## 8.0 Roof amendments

**11.3 LB Camden pre-application response letter**

**Re: 13-17 Fitzroy Street, London, W1T 4BQ**

Fig. 9.6 - Proposed Cycle Storage

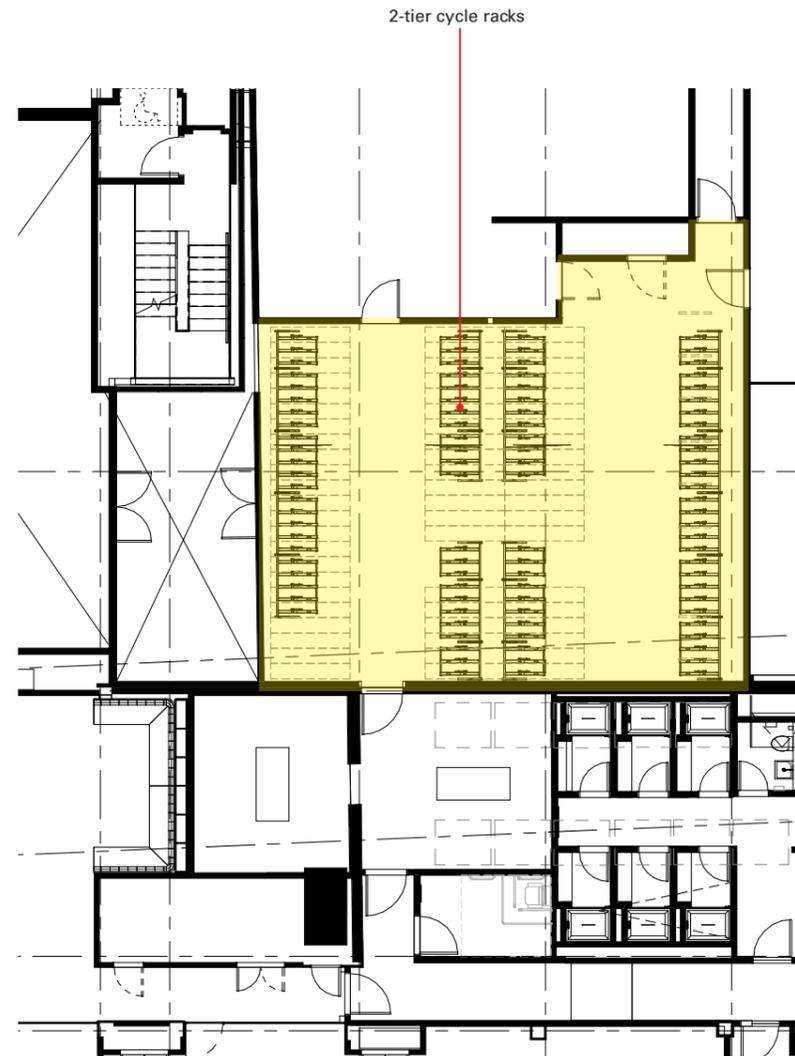
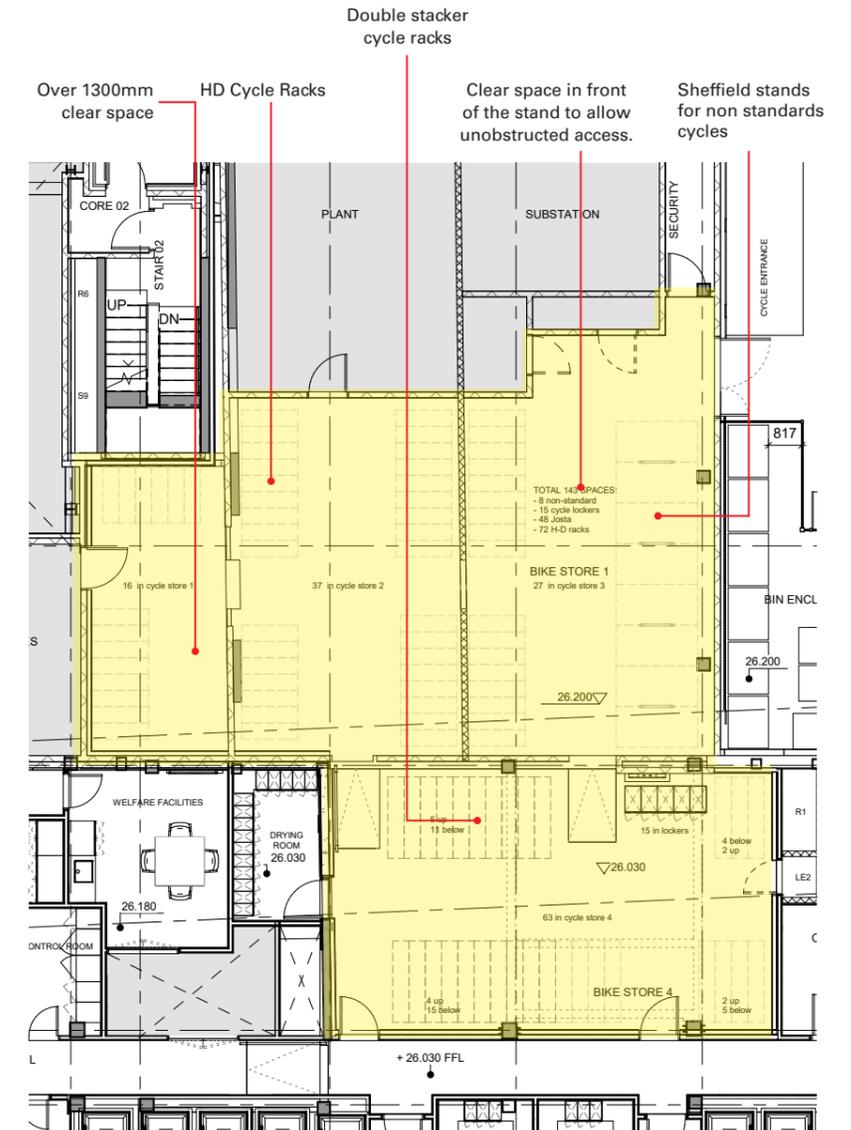
9.1.2 The consented scheme proposed 2-tier cycle racks within the cycle store, however following a recent survey of the floor to ceiling heights in this area, there is not sufficient height to accommodate 2-tier racks within the existing cycle store. Therefore the proposals extend the cycle store to allow for the correct quantity of cycle racks.

- The proposed scheme provides 143 long-stay cycle spaces for the building which does not include any vertical or semi-vertical cycle parking spaces.
- The high-density cycle racks allow the bicycle to be locked from both the front and rear.

- 5% of the total number of cycle spaces are allocated to non-standard cycles. These have been provided in the form of Sheffield stands that have additional width between stands and are located adjacent to the cycle store entrance. These will be clearly identified denoting they are for non-standard cycles.

- The entrance into the cycle store is level access. Internal ramps have been provided within the cycle store to accommodate the change in level within the existing building.

- The external door into the cycle store is a leaf and a half with a total width of 2m. This will have an external push button that will automatically open the door. There are no other internal doors that the cycles must traverse, however the openings in the existing internal walls are 1155mm wide.
